HISTORIC LANDMARK COMMISSION STAFF REPORT

**Newhouse Apartments
New Construction
PLNHLC2012-00538
540 East 500 South
December 6, 2012**

Strategic Capital Group, represented by Adam Paul, requests approval to construct a multi-family structure at approximately 540 East 500 South. The demolition of the existing office building on the site was approved by staff on April 26, 2012.

FRONT ELEVATION

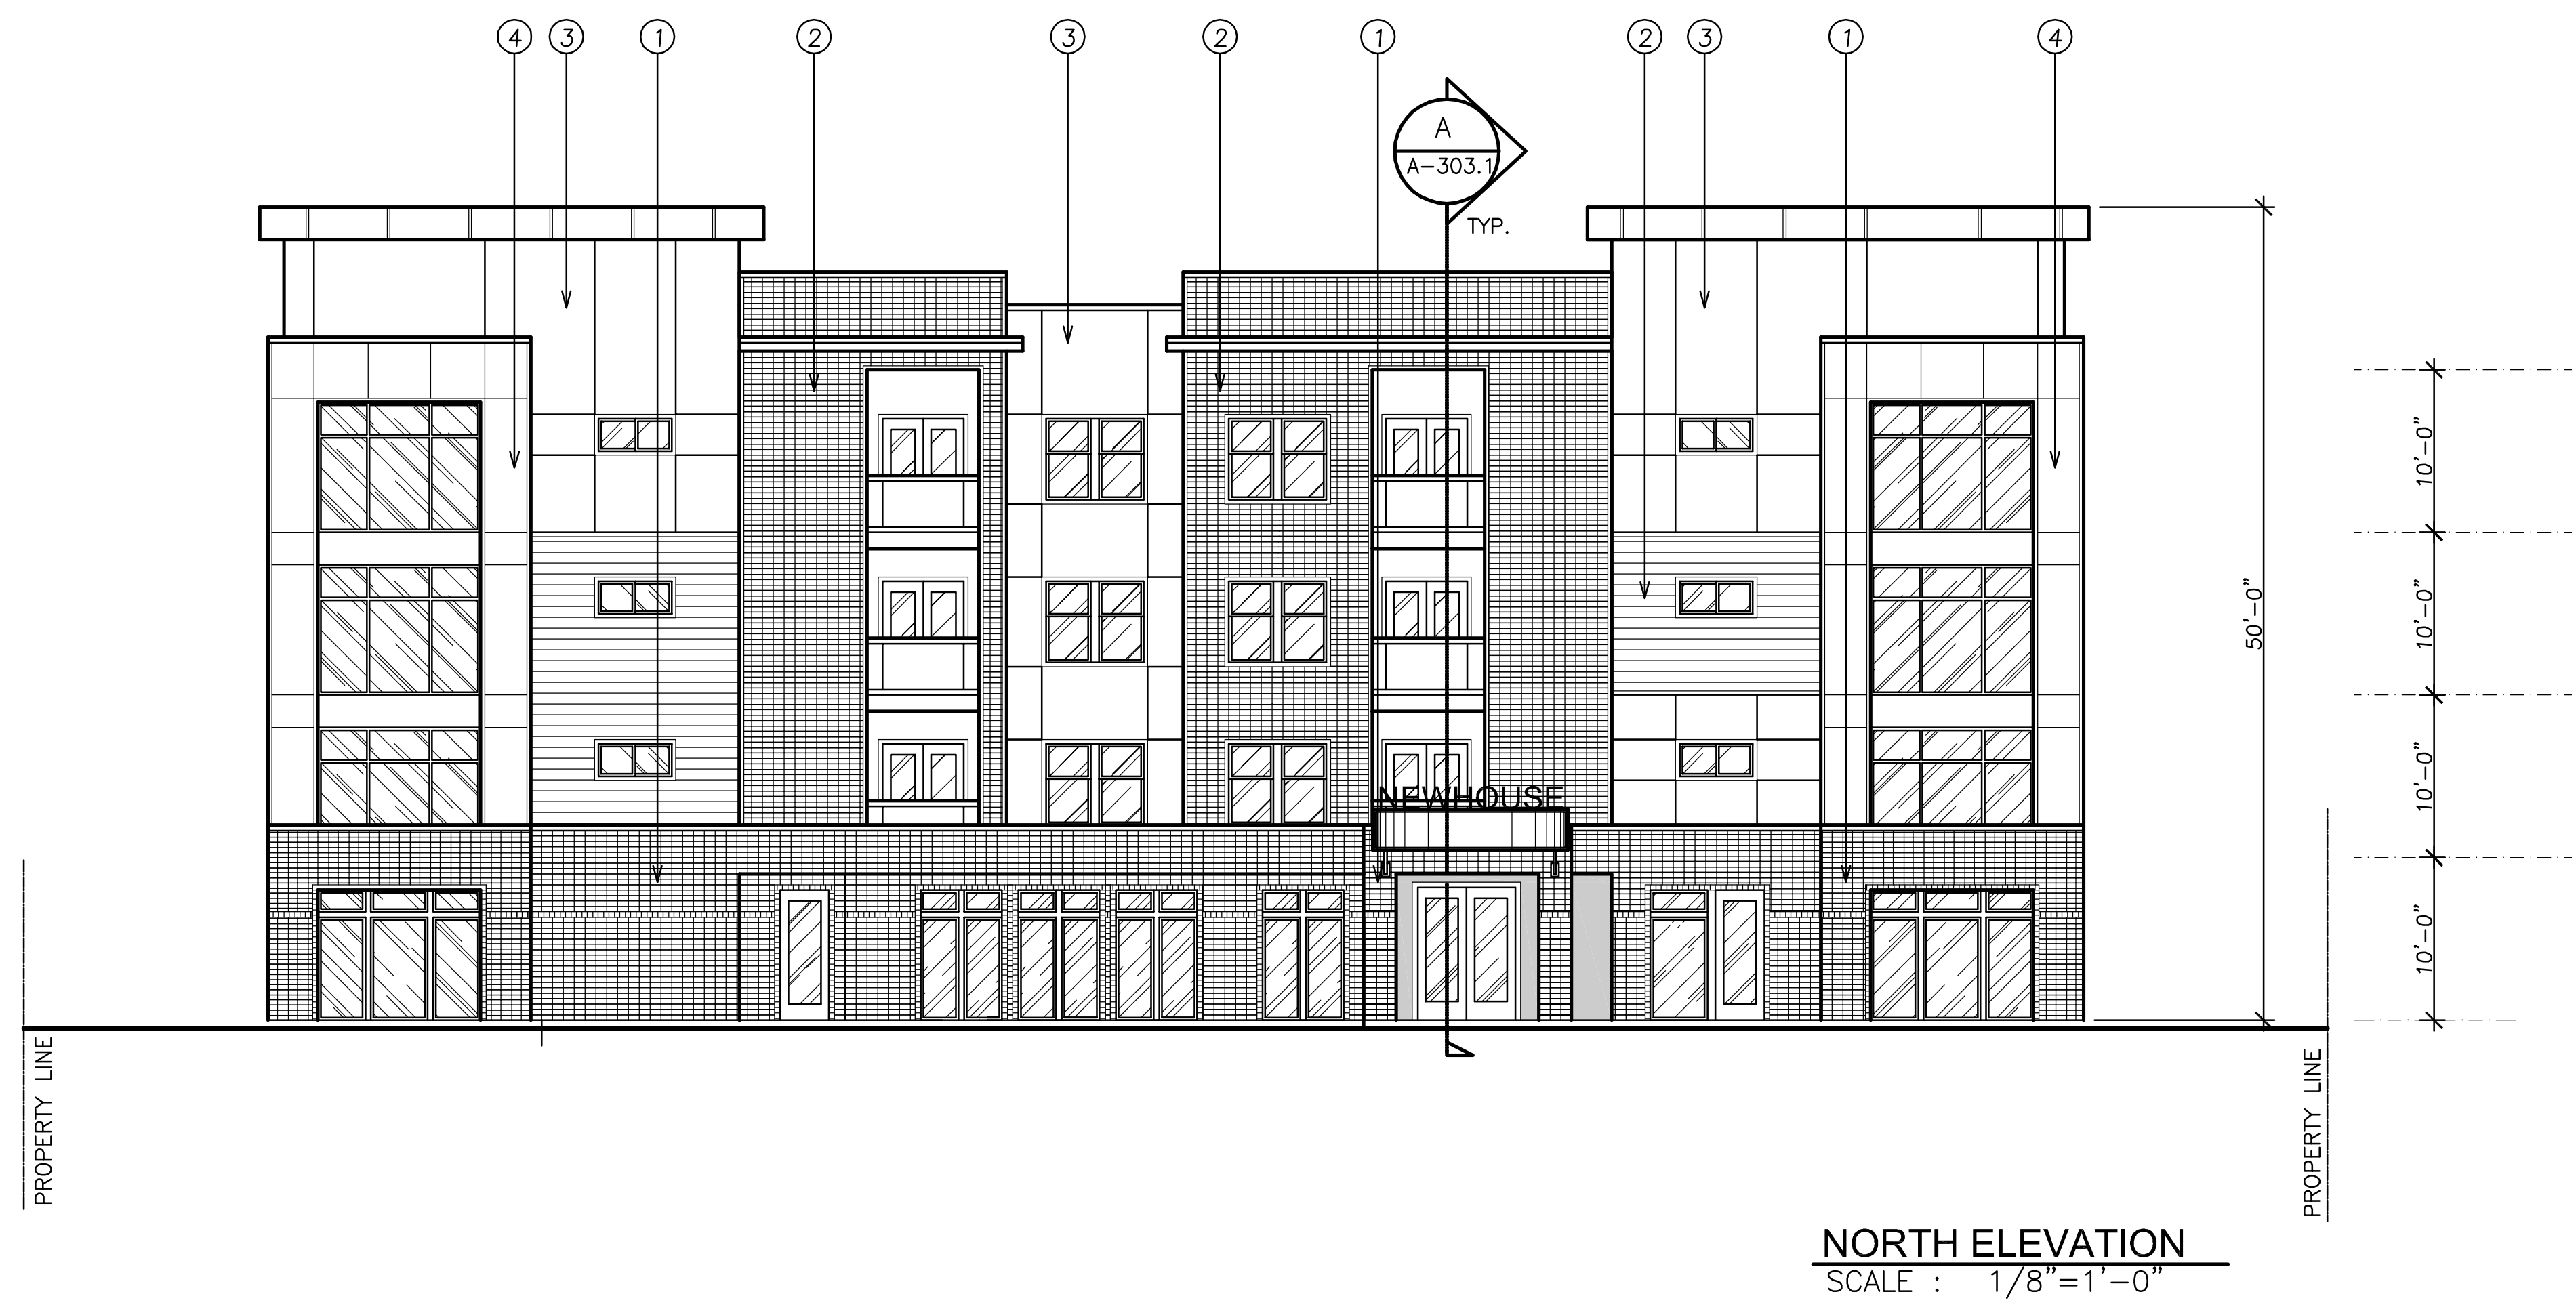
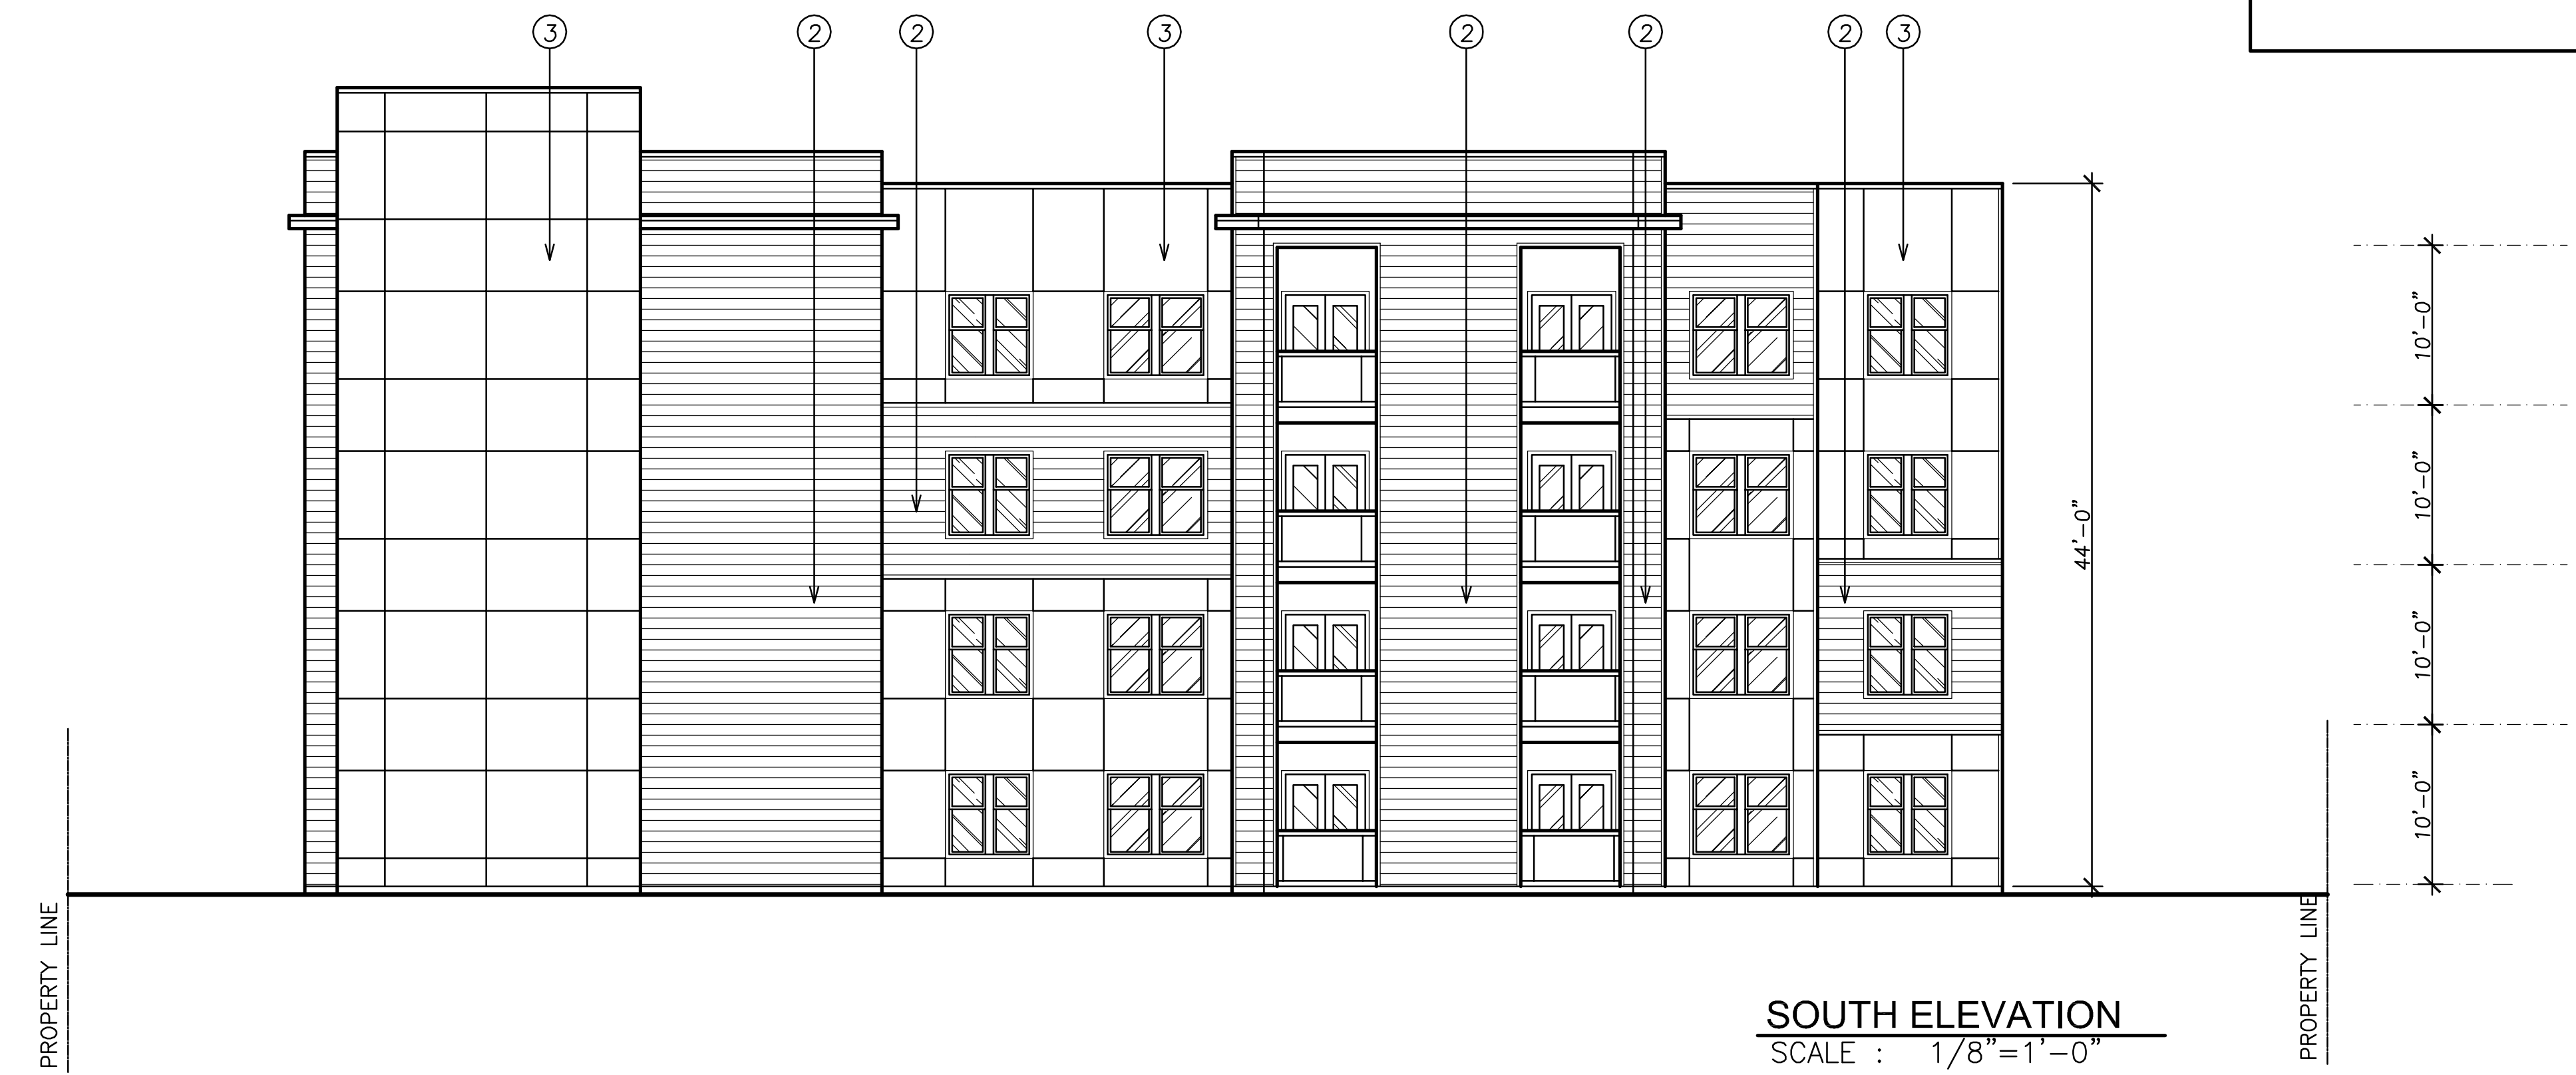
1. The front elevation has been modified. Our previous design showed brick extending only up 1 level. The new design has masonry extending all the way to the roof. We experimented with masonry locations and originally thought it would be better to extend it at the corners of the buildings. After revising the rendering, we discovered that masonry at the corners actually focused attention to the center of the building and de-emphasized the corners. We prefer to keep the accent materials and colors at the corners and masonry in the center. It also helps to simplify the design. Please review the updated colored rendering. Notice that the trees in the rendering have been removed to show the building without obstruction. When the project is built, there will be trees and we suggest they will provide a good layer of screening between the street and the building.

Vice Chair Hart stated the only change she could find between the first submittal and the second was the removal of one green block and the name banner over the door. She asked if there were any other changes.

There was a question about the differentiation in design on the front elevation. Different committee members noted that there wasn't symmetry in the building and it looked like the building was split in two. Mr. Tuttle answered that the proposal was not symmetrical because the applicant did not want to fake historic.
